NOTE TO: R. Bernero
G. Arlotto
R. Browning
B.J. Youngblood
R. Ballard
J. Linehan
P. Justus

FROM: J. Trapp

SUBJECT: Probability of Volcanism at Yucca Mountain

PROBABILITY OF VOLCANISM AT YUCCA MOUNTAIN

COMPARISON OF VOLCANIC SCENARIOS

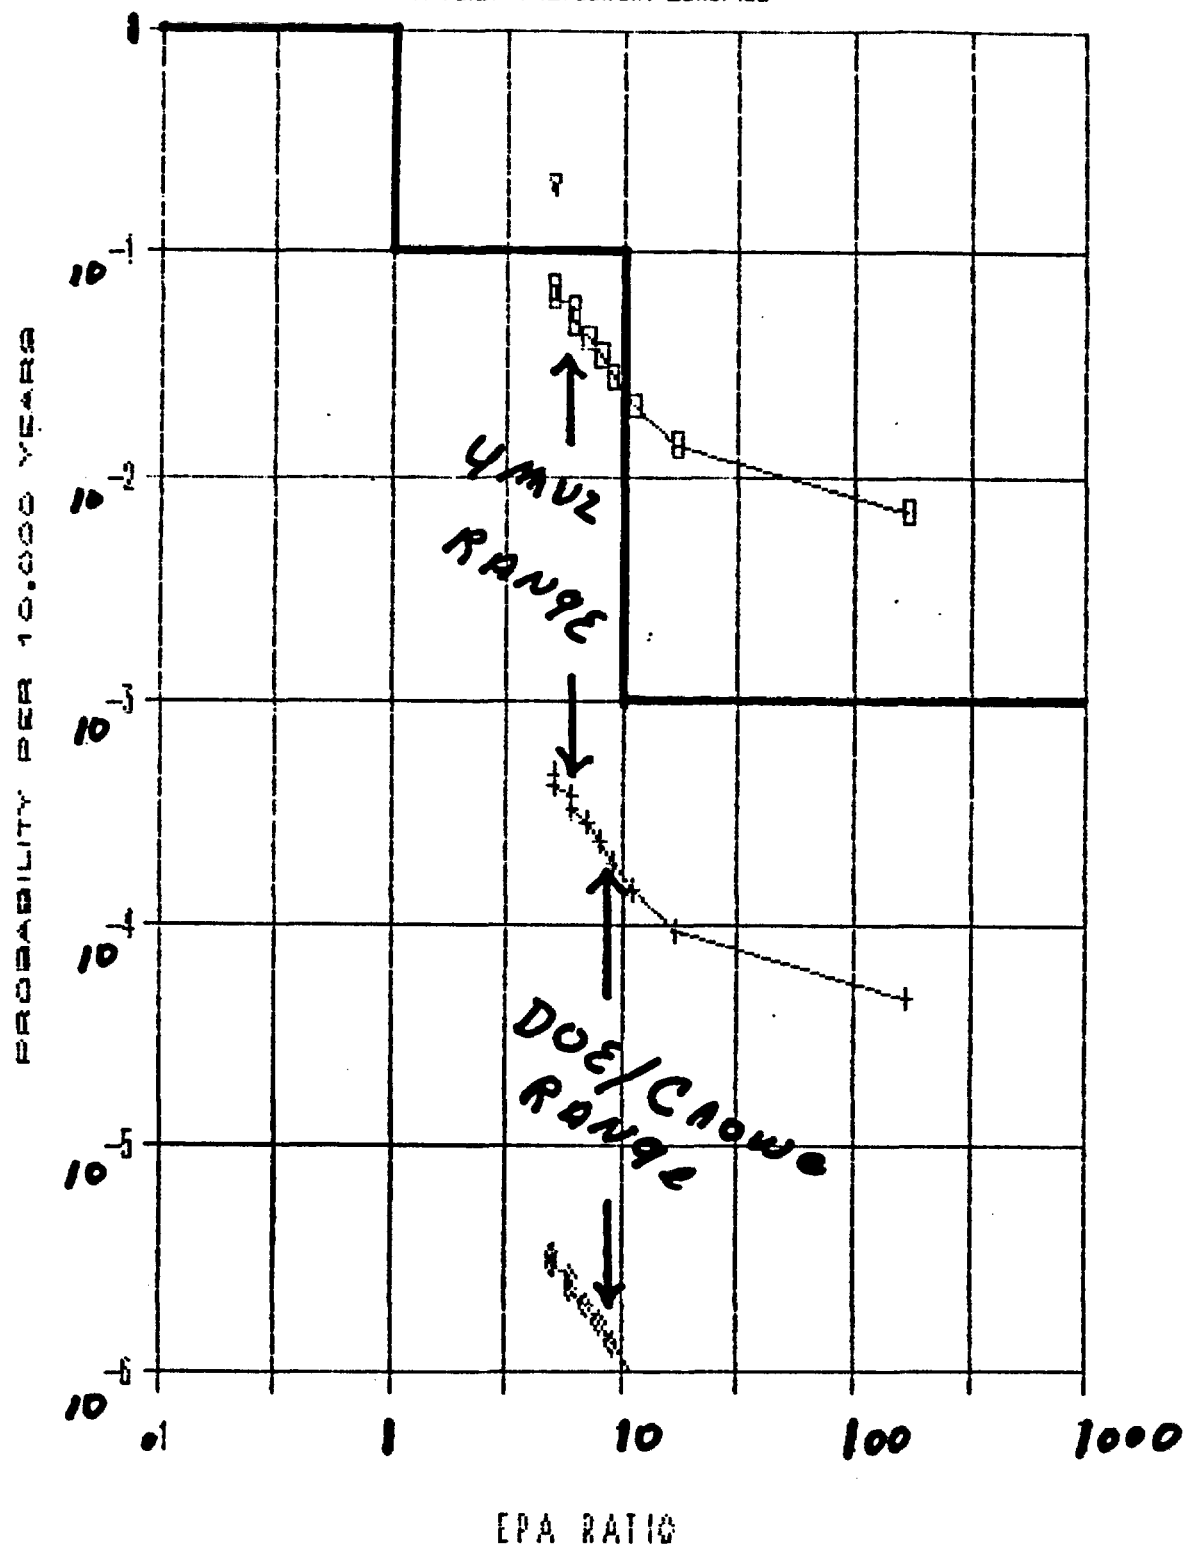
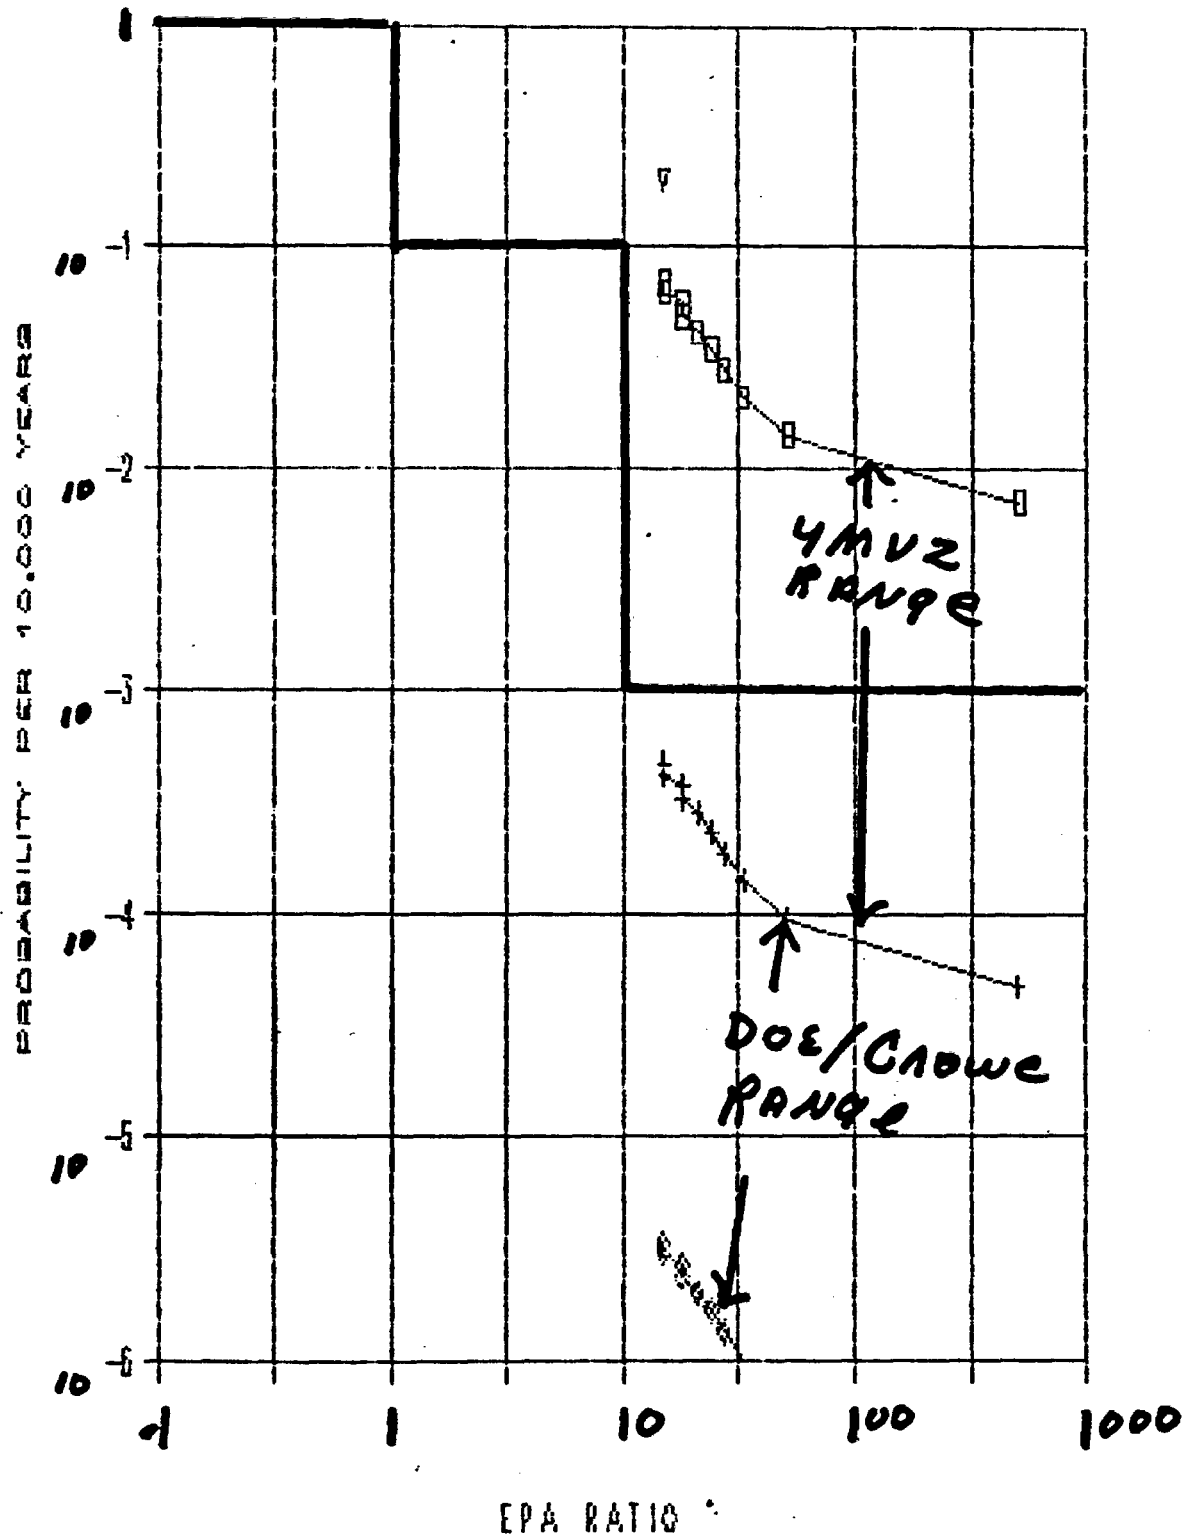
To allow a comparison of the various scenarios discussed in this note I am attaching two drawings showing the interpreted range in effects as would be expressed on a CCDF chart. The fact that this is being expressed as lines, rather then points, is to take into consideration radioactive decay. I have used .1 and .3 percent disruption of the repository for the base cases as these values approximately correspond to the measured sizes of the two plugs. The probability values presented do not consider the potential effects of multiple eruptions or increasing the zone of influence around the site, therefore, I consider the numbers as unconservative. The consequence values also do not cover the full range -- I could come up with more or less in many ways -- but are probably reasonable approximations of expected values. I do consider that this chart represents the problems which would confront the licensing board if this site were to undergo licensing today.

COMPARISON OF VOLCANIC SCENARIOS

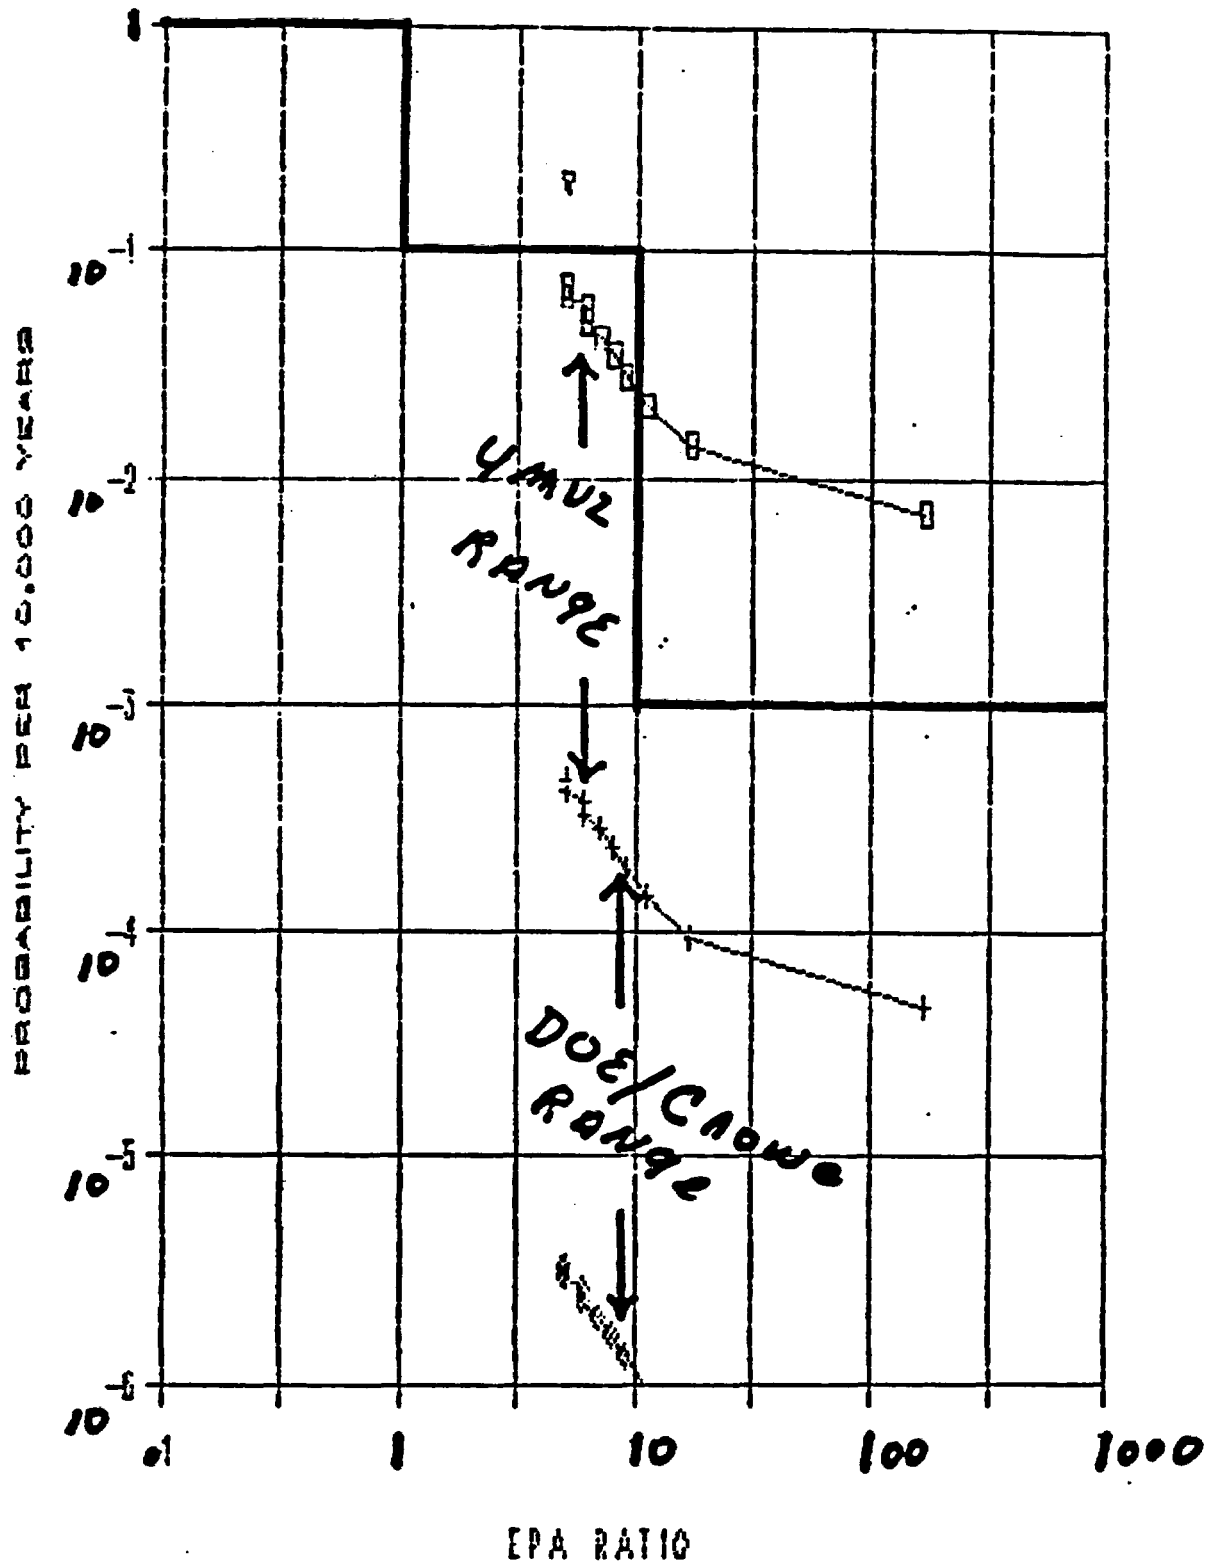
To allow a comparison of the various scenarios discussed in this note I am attaching two drawings showing the interpreted range in effects as would be expressed on a CCDF chart. The fact that this is being expressed as lines, rather than points, is to take into consideration radioactive decay. I have used .1 and .3 percent disruption of the repository for the base cases as these values approximately correspond to the measured sizes of the two plugs. The probability values presented do not consider the potential effects of multiple eruptions or increasing the zone of influence around the site, therefore, I consider the numbers as unconservative. The consequence values also do not cover the full range -- I could come up with more or less in many ways -- but are probably reasonable approximations of expected values.
